DRAINAGE INFORMATION SHEET

PROJECT TITLE: JIM'S AUTOMOTIVE

ZONE ATLAS/DRNG. FILE #: K17/D77

RE: ENGINEER CERTIFICATION FOR JIM'S AUTOMOTIVE (K17-D77) CERTIFICATION
STATEMENT DATED 7/23/98

GRADING AND DRAINAGE PLAN
LOT A & B OF WILLIAM J. BENN'S REPLAT OF LOTS 8, 9, 10 & 11 IN BLOCK 15 OF MESA GRANDE ADDITION ALBUQUERQUE, BERNALILLO COUNTY, NEW MEXICO

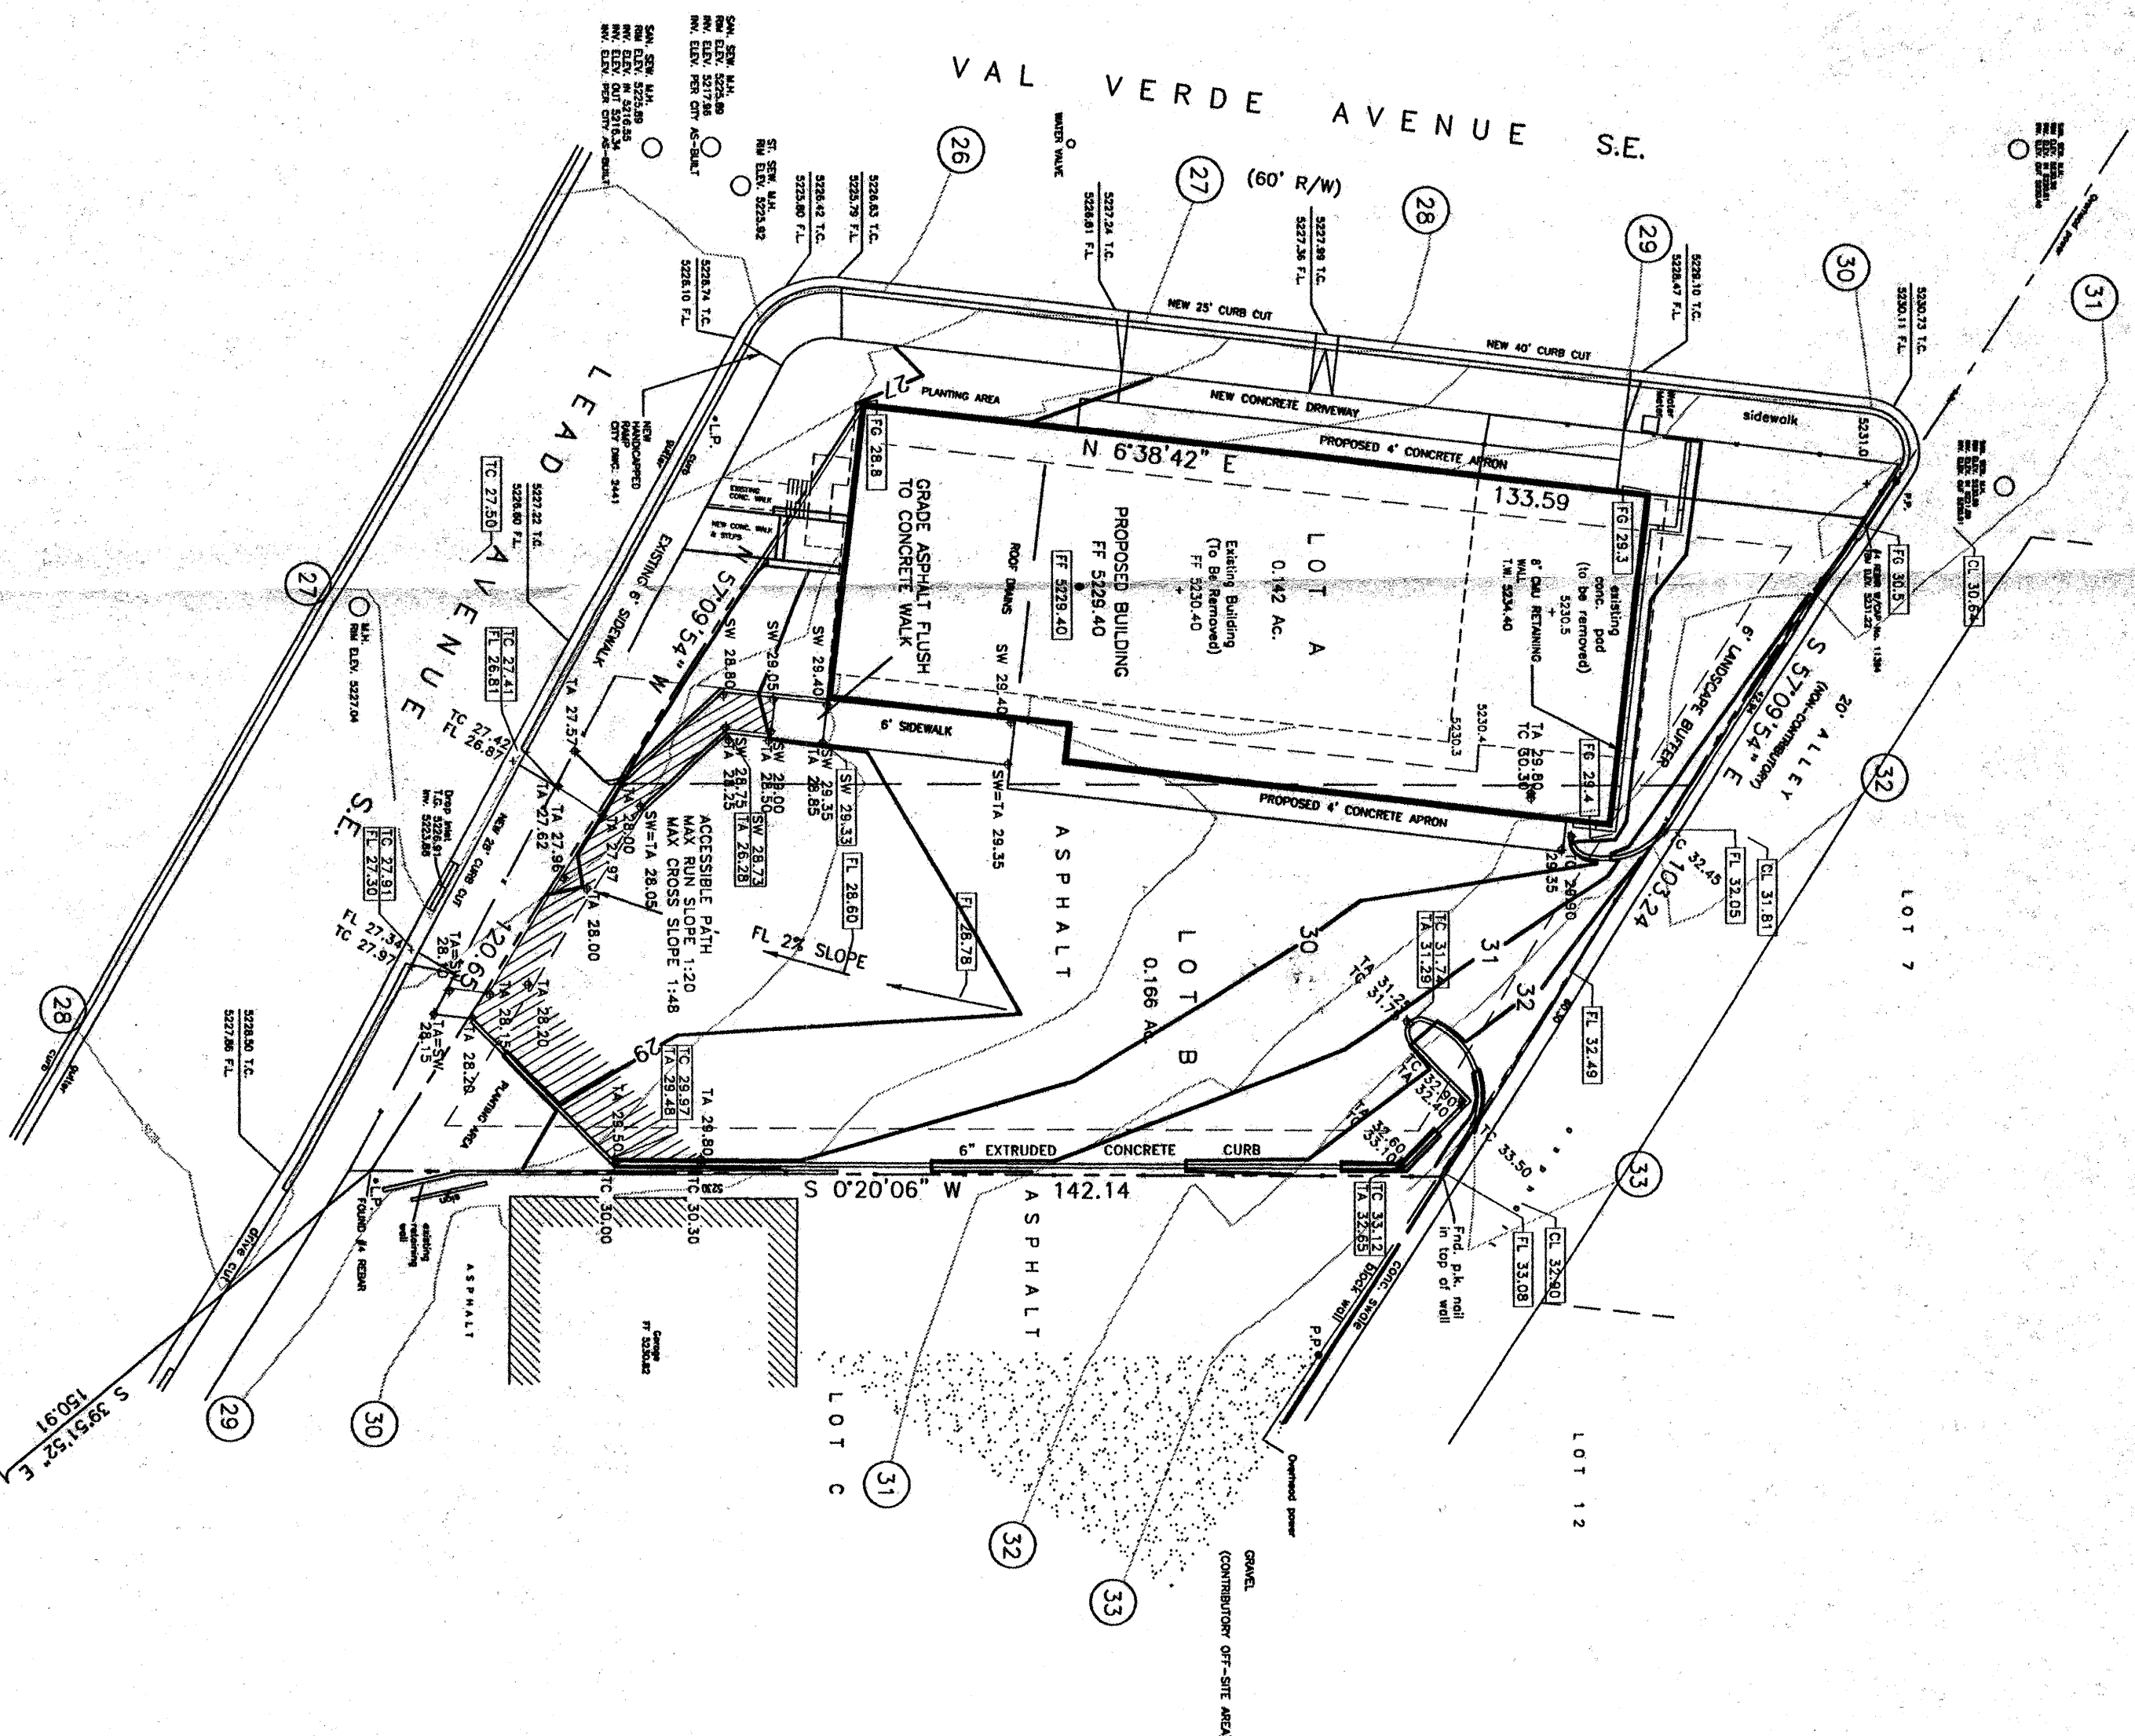
Based on the information provided on your July 23, 1998 submittal, Engineer Certification for the above referenced site is acceptable.

Please be advised that the permanent CO will not be issued until a copy of the letter of acceptance for the Work Order construction.
